P/N: IASFB0A1
KEY P/N: IKSFB000

SCALE: 1:1	UNIT: M/M	DRN BY SRZ	DATE 3/13/07	NUTEK CORPORATION			
MATERIAL	CHK BY VICTOR		TITLE		SH 433-120 IVU		
FINISH	APPD BY YGF		SIZE		DEPT	DRAWING NO	REV
CODE	SHEET OF		A4			9610070	1

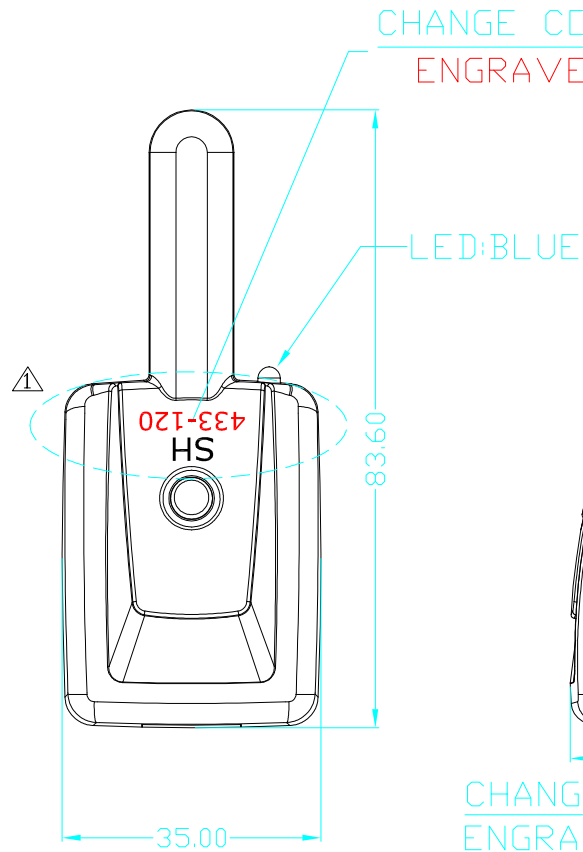
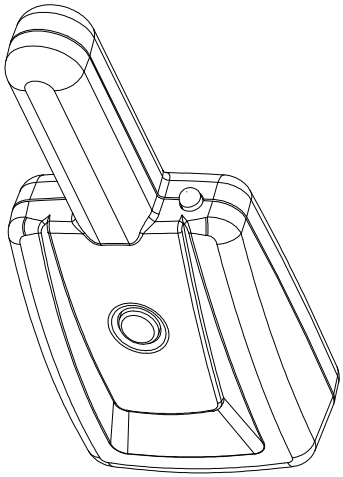
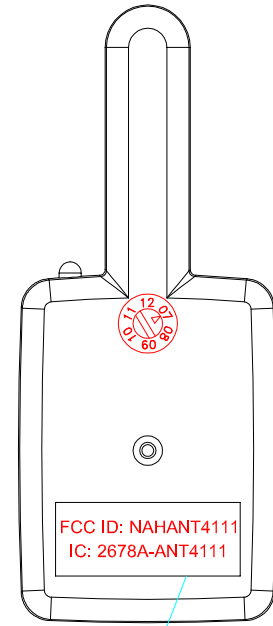
CHANGE CORE(CAVE=0.2,FLASH)
ENGRAVED(RAISED=0.2,MT-11010)

REVISIONS				
REV.	ACC.	DESCRIPTION	DRN.	DATE
1		ADD ENGRAVING	SRZ	3/28/07
